SUTHERLAND SHIRE COUNCIL ASSESSMENT REPORT

Panel Reference	2018SSH030
DA Number	MA18/0164
LGA	Sutherland Shire
Proposed Development:	S4.55(2) Modification to DA15/0947 - External and internal reconfiguration and reduction in number of units to 3 on level 8 and replacement of roof elements with 3 skylights
Street Address:	Lot 22, 23, 24, 25 and 26 DP 26174 (No. 6 to 14) Urunga Parade, Miranda
Applicant/Owner:	Ms J Bezzina
Date of DA lodgement	10 May 2018
Number of Submissions:	No Submissions
Recommendation:	Approval
Regional Development Criteria (Schedule 7 of the SEPP (State and Regional Development) 2011)	Originally approved development exceeds \$20 million CIV (modification under s.4.55(2)).
List of all relevant s4.15(1)(a) matters	- State Environmental Planning Policy No. 65 - Design Quality of Residential Apartment Development - State Environmental Planning Policy (Building Sustainability Index: BASIX) 2004 (BASIX) - Sutherland Shire Local Environmental Plan 2015 (SSLEP2015) - Sutherland Shire Development Control Plan 2015 (SSDCP2015) - Apartment Design Guide (AGD).

Figure 1 – Approved south elevation (MA16/0129)

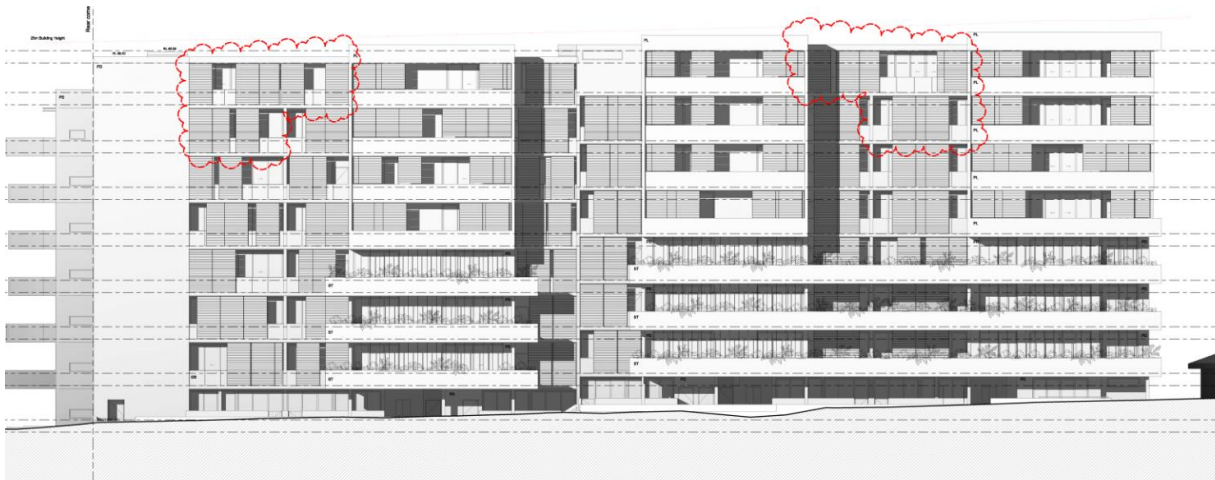
The additional gross floor area (GFA) is situated at the rear of the building or situated within the existing basement envelope and will not be visible from Urunga Road or from adjacent properties to the east or west. Elevation diagrams are provided below at Figures 1 and 2 which indicate the external appearance of the building as viewed from the railway line and properties situated to the south.

The enclosure of balcony areas will not result in an appreciable change in the overall bulk or scale of the building, partly due to the position and size of proposed external walls relative to the overall composition of the building, and also having regard for the size of approved screening devices on balconies. The changes will not increase overall density of the site, reduce amenity of adjoining land or the public domain, nor cause any additional overshadowing impacts. The loss of balcony space is offset by the substantial north facing balconies which serve each apartment. The GFA increase is supported on the basis that it will not add to the tangible bulk of the building or have any adverse impacts on adjacent or nearby properties and will satisfy the underlying floor space and zone objectives, notwithstanding the relatively minor numerical inconsistency. The contravention of the standard does not raise any matter of significance for state or regional environmental planning and there is no public benefit of maintaining the development standard in the circumstances of this particular case.
